UNITED STATES PATENT AND TRADEMARK OFFICE

APPLICATION NO.	FILING DATE	FIRST NAMED INVENTOR	ATTORNEY DOCKET NO.	CONFIRMATION NO.
09/719,138	02/08/2001	Hirokazu Fujino	0020-4783P	5320

Office Action Summary

DETAILED ACTION

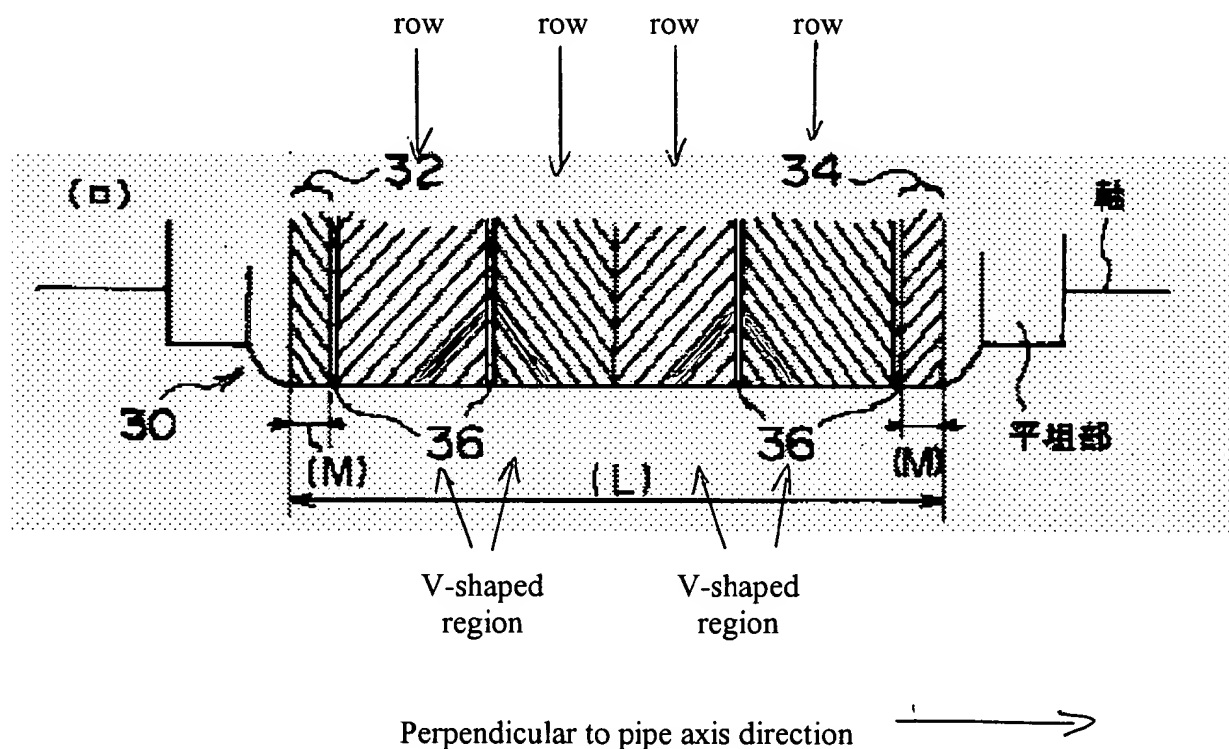
Figure 1 of Yamamoto et al discloses a device and method for manufacturing a heat-transfer pipe with internal grooves comprising a first marking roll 30 forming first and second rows of parallel grooves (in red) to forming a series of V-shaped regions (in red, Figure 2 below) repeating along a line on the inner surface perpendicular to the pipe axis direction. Further, the width of the two rows of parallel grooves is different.
